Spokane Park Board Agenda

Aug. 10, 2017 – 1:30 p.m.

CITY OF SPOKANE
PARKS AND RECREATION DEPARTMENT
CHANGE ORDER NO. 4

CENTER POST CABLE TIE-OFF DETAIL

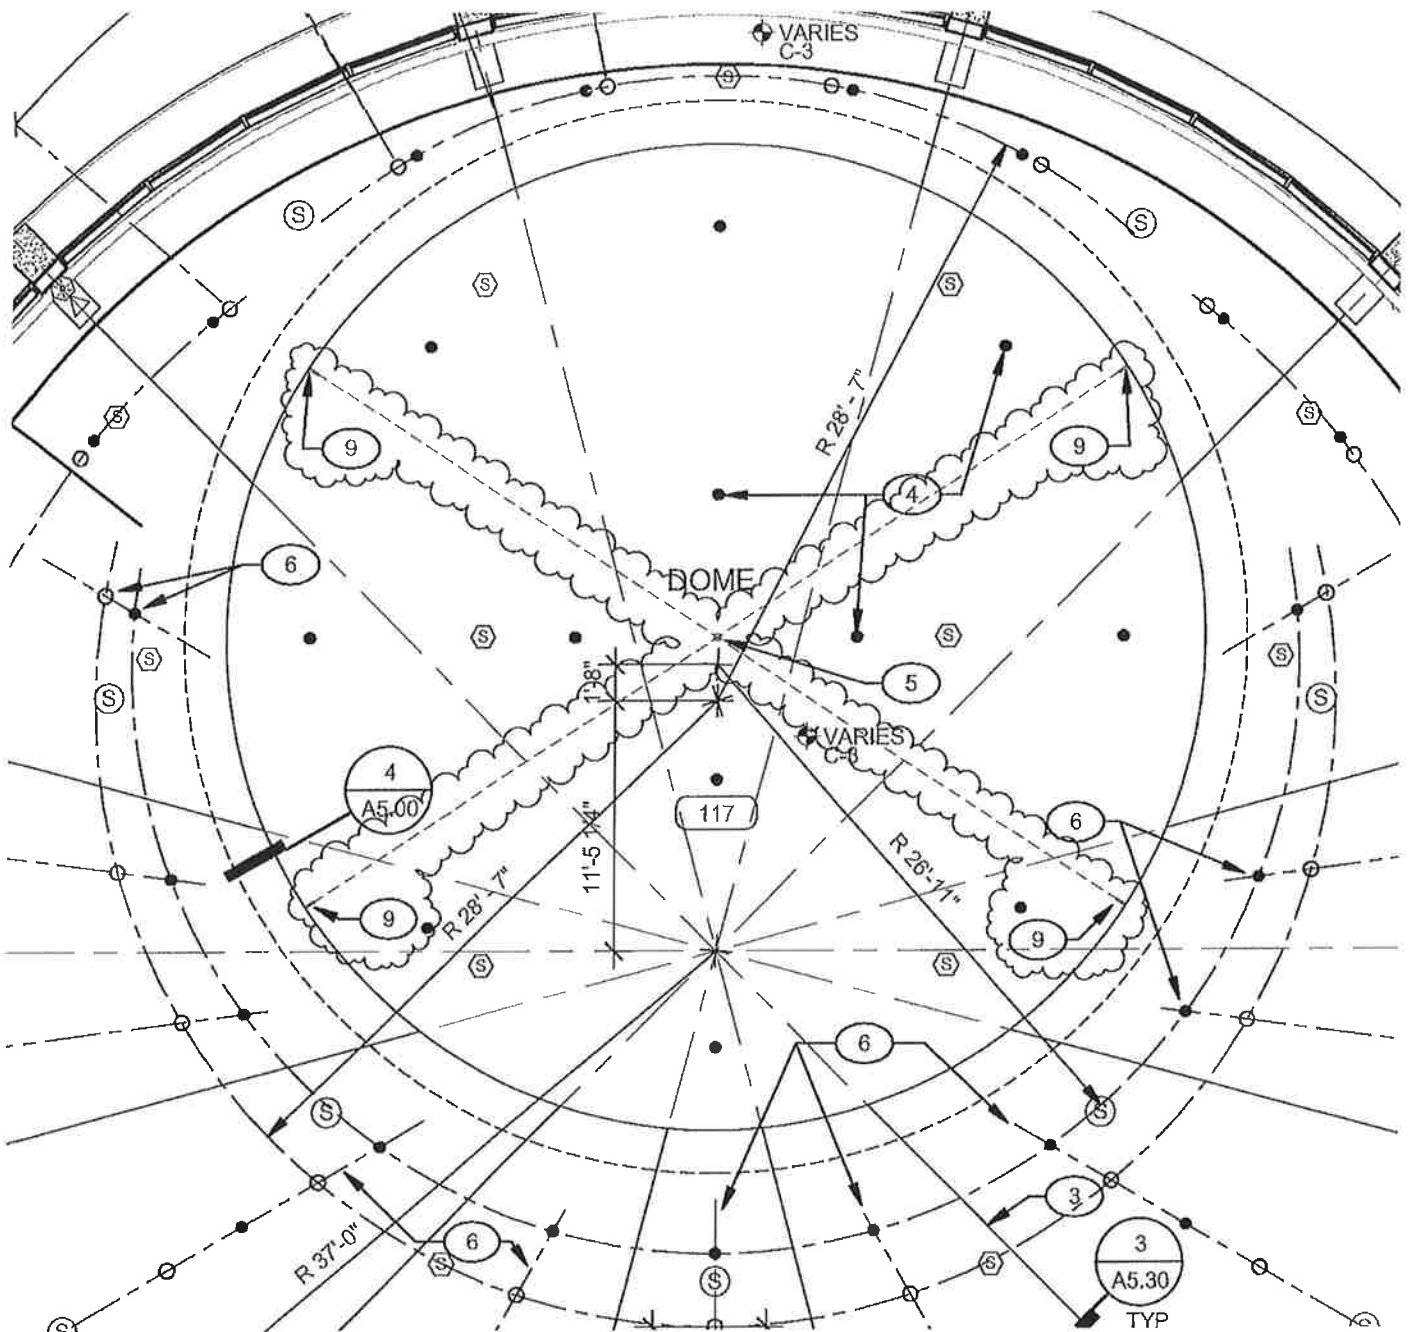
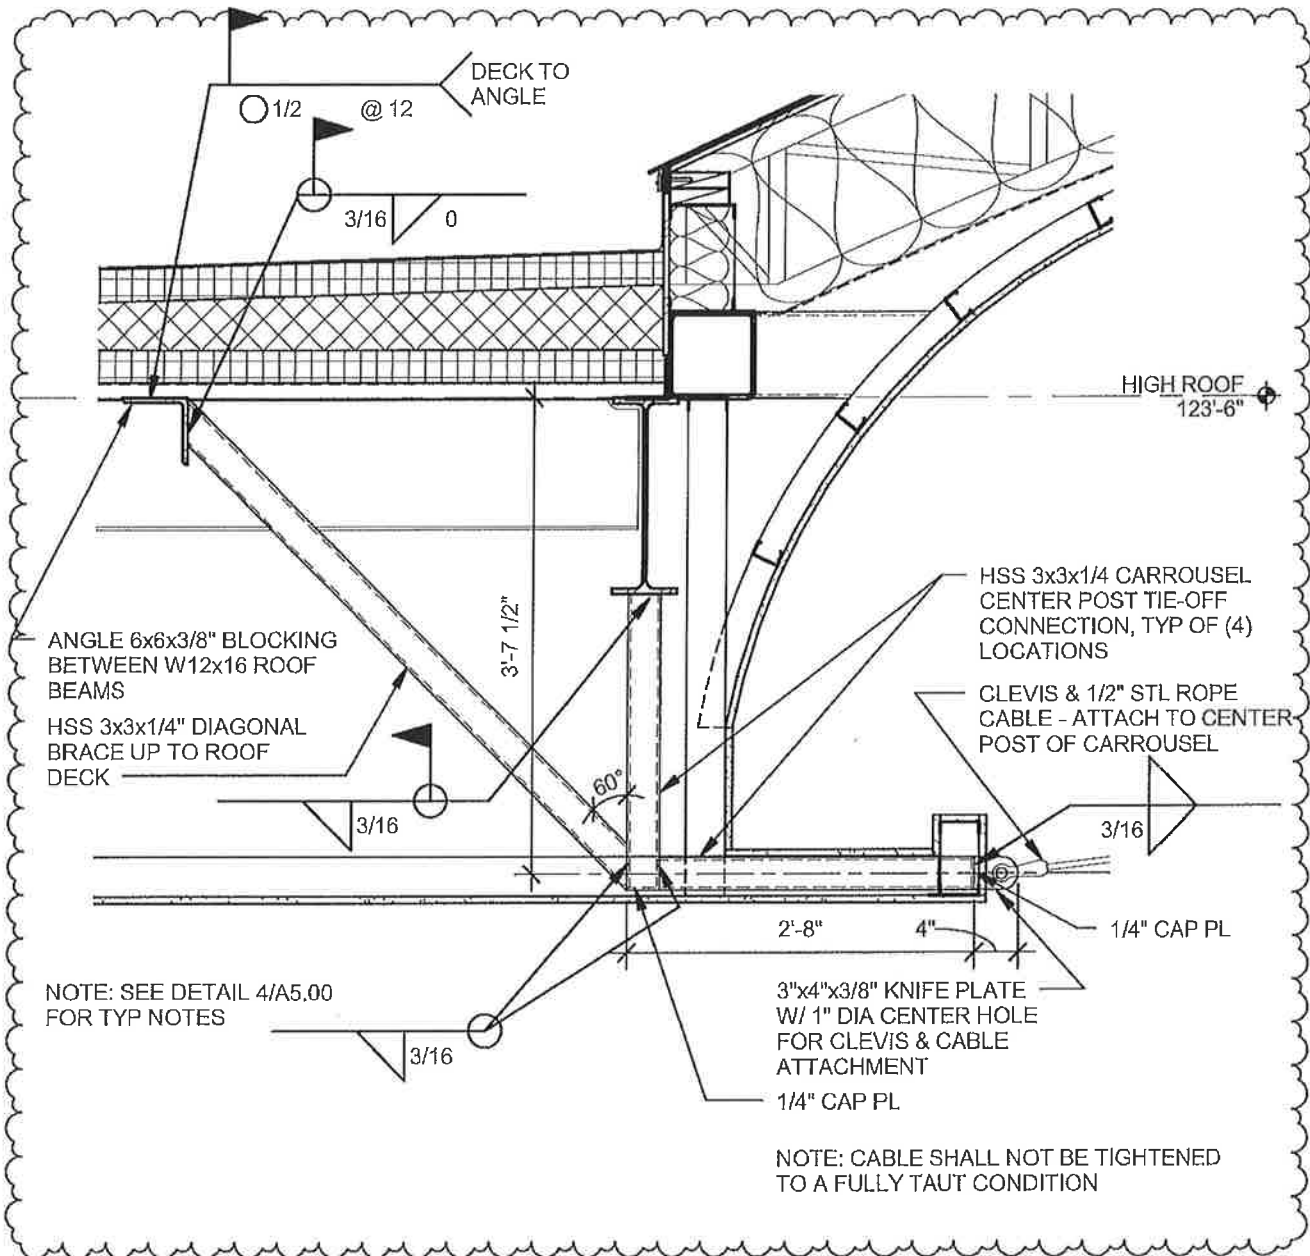
Add cable to tie-off the carrousel center post as shown on attached drawings CA-43 and CA-44. Final connection to the carrousel center post to be made by the Owner. Confirm necessary cable length and hardware with Owner to accommodate connection to the carrousel.

- 8 MDF PANELS TO WRAP ON TO GYP SOFFIT
 9 CARROUSEL CENTER POST TIE-OFF LOCATION. SEE DETAIL 7/A5.00.
 LOCATE TIE-OFF ASSEMBLY AT MID-POINT OF W18 BEAMS, TYP OF (4)

PROJECT NO 111-16000
 FILE CE-09
 DRAWN WMM
 CHECKED JKS
 DATE 05/01/17

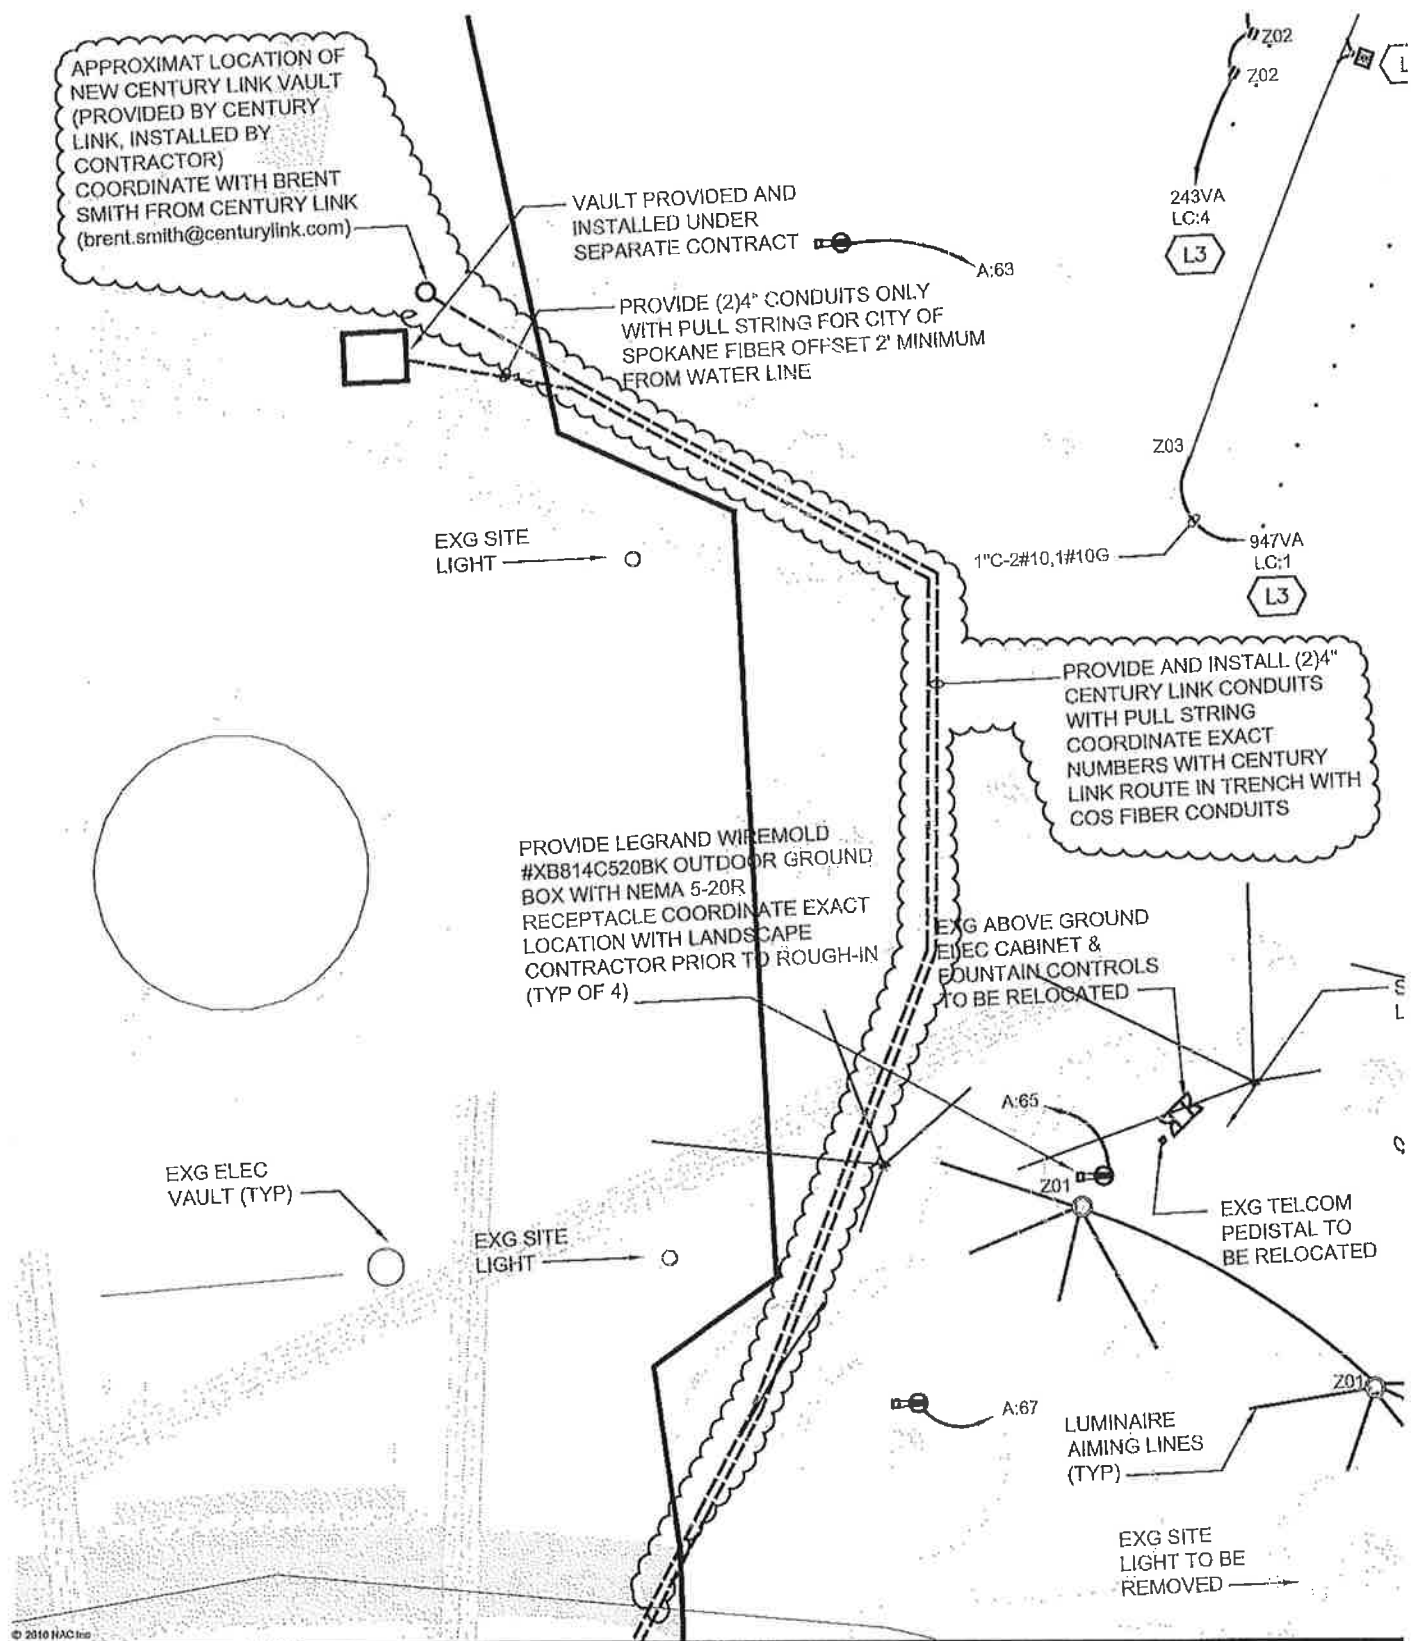
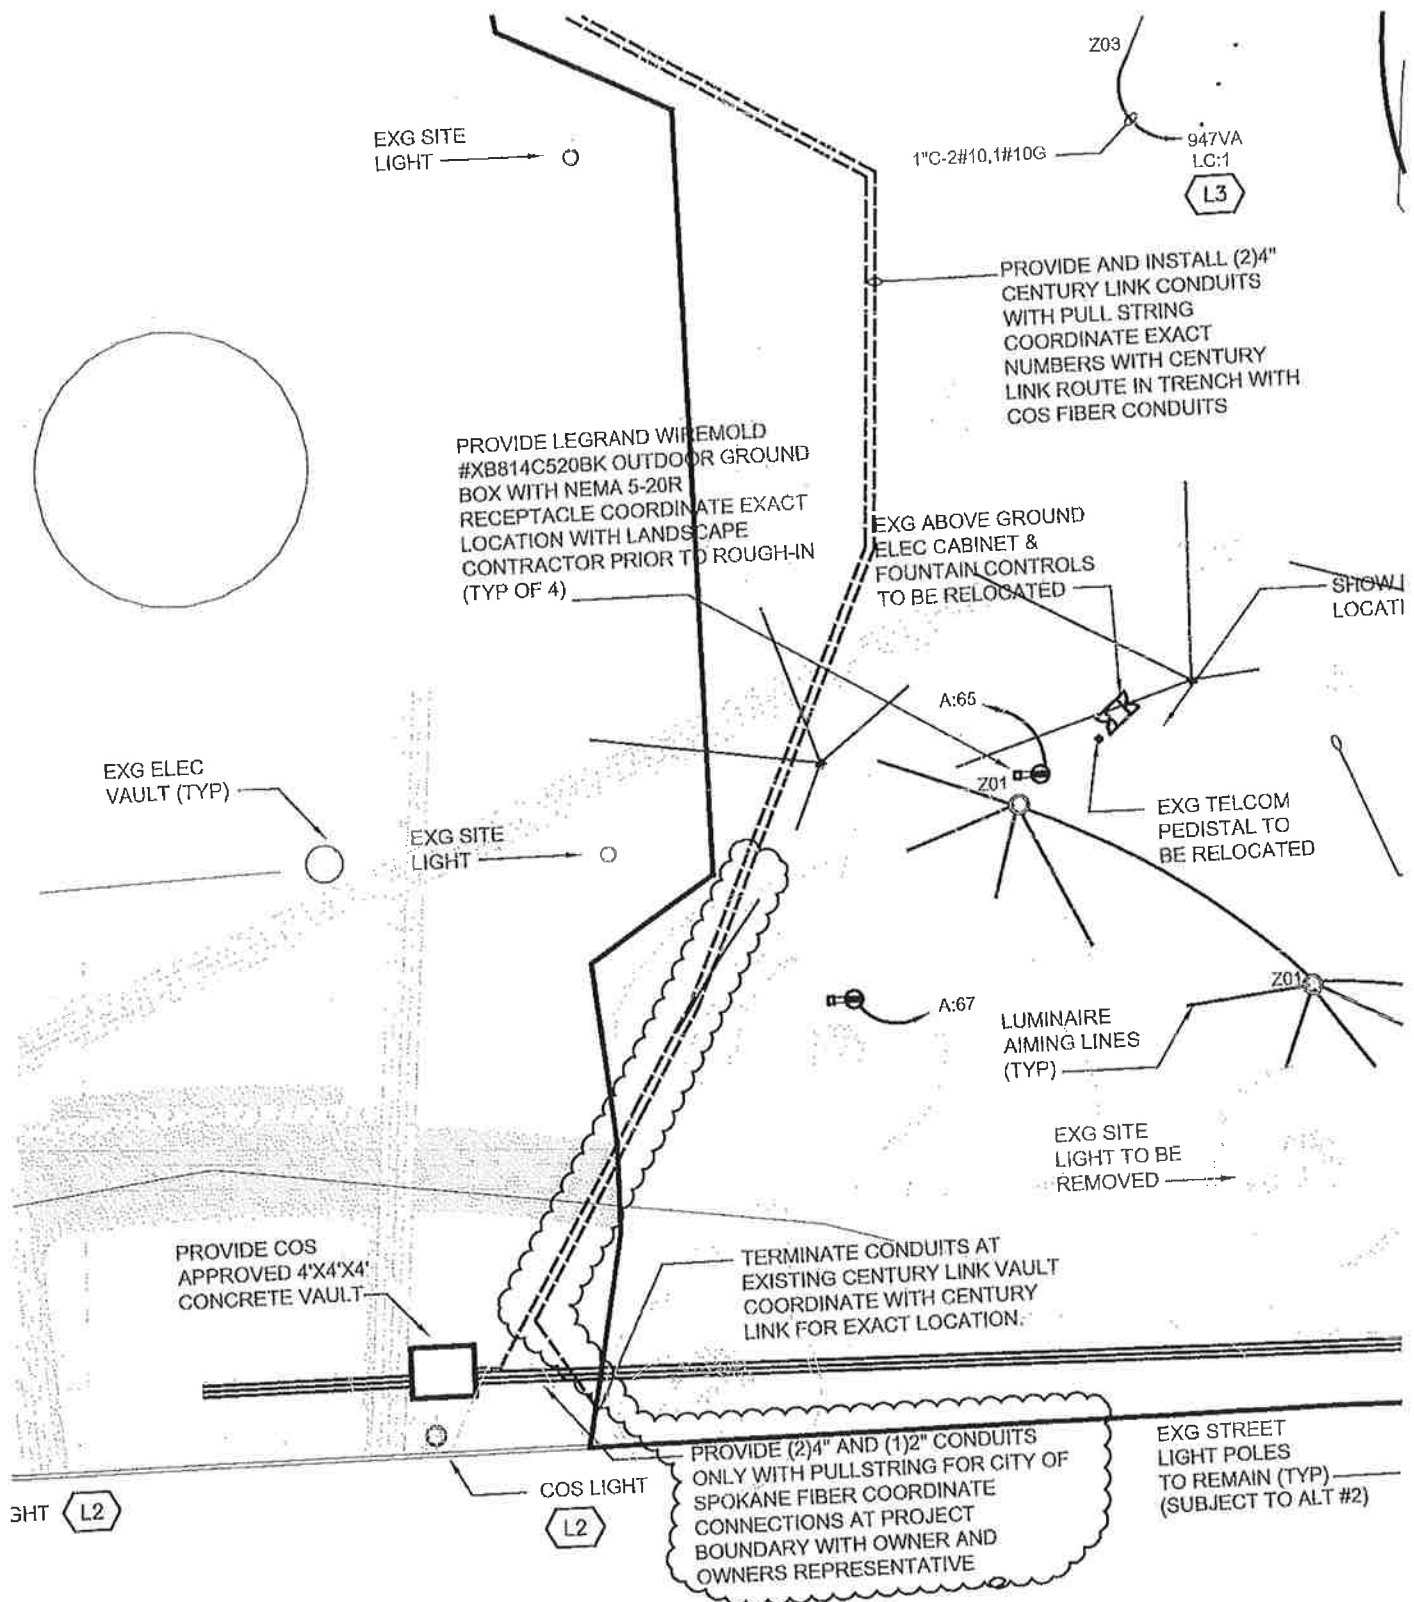
Add CenturyLink Vaults and Conduits as Indicated on attached drawings CE-34 and CE-35.

SHEET 1 OF 3
L1.0
SITE PLAN

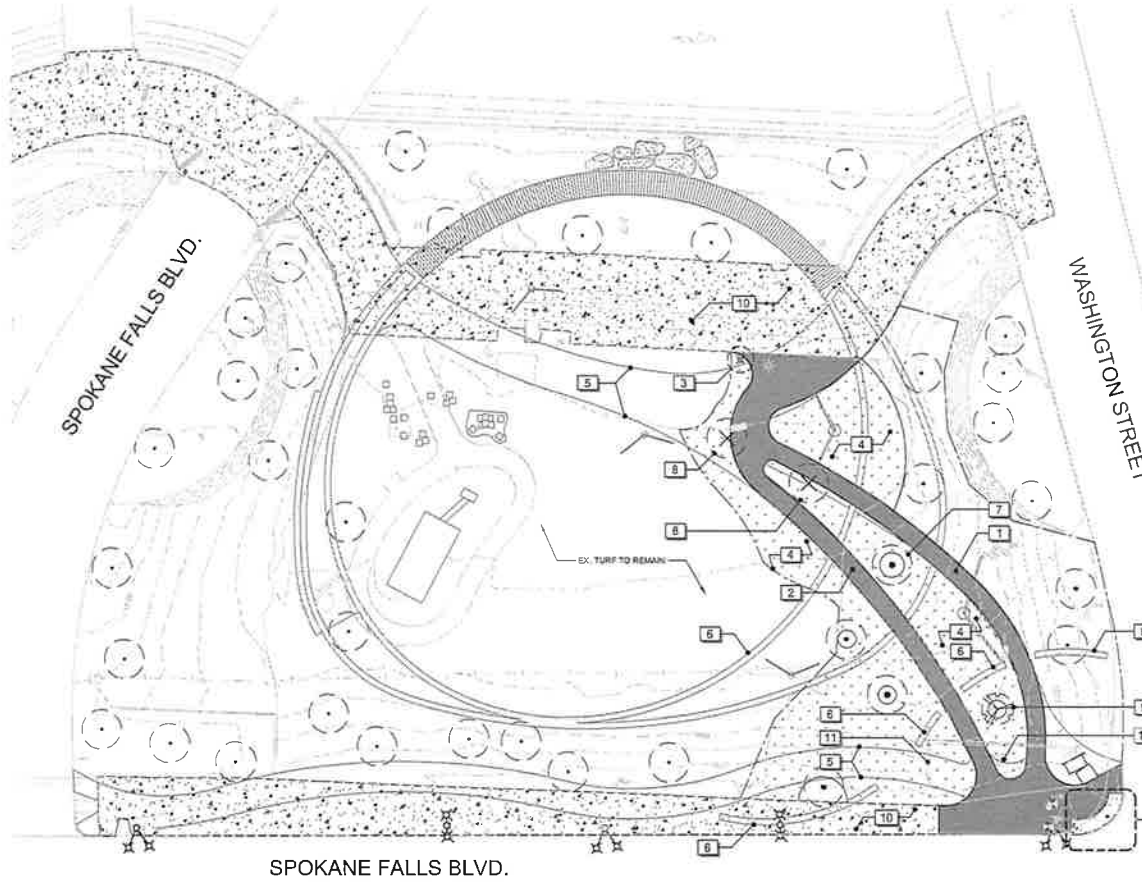
Complete demolition, Irrigation, landscape and other site work as indicated by attached "RFP SOUTH BANK EAST" drawings (10 drawings). With proposal, include "base bid" cost and separate added cost for alternate nos. 1 and 2 as indicated on sheet L1.0.

1. INSTALL 2" THICK CONCRETE WALKWAY PER CITY OF SPOKANE STD, DETAIL F-102 IN LIEU OF ASPHALT PAVEMENT.
2. SUPPLY CDF BASE MATERIAL IN LIEU OF CSTC WITHIN TREE PROTECTION ZONES.

1. INSTALL (2) NEW CONCRETE CURB RAMPS PER CITY OF SPOKANE STD, DETAIL F-105.
2. FIRST CURB RAMP SHALL BE LOCATED AS SHOWN PER PLANS AND THE SECOND LOCATION SHALL BE LOCATED ACROSS WASHINGTON STREET TO THE EAST FROM PROJECT SITE.
3. INCLUDE ALL TEMPORARY TRAFFIC CONTROL AS REQUIRED TO ACCOMPLISH WORK.
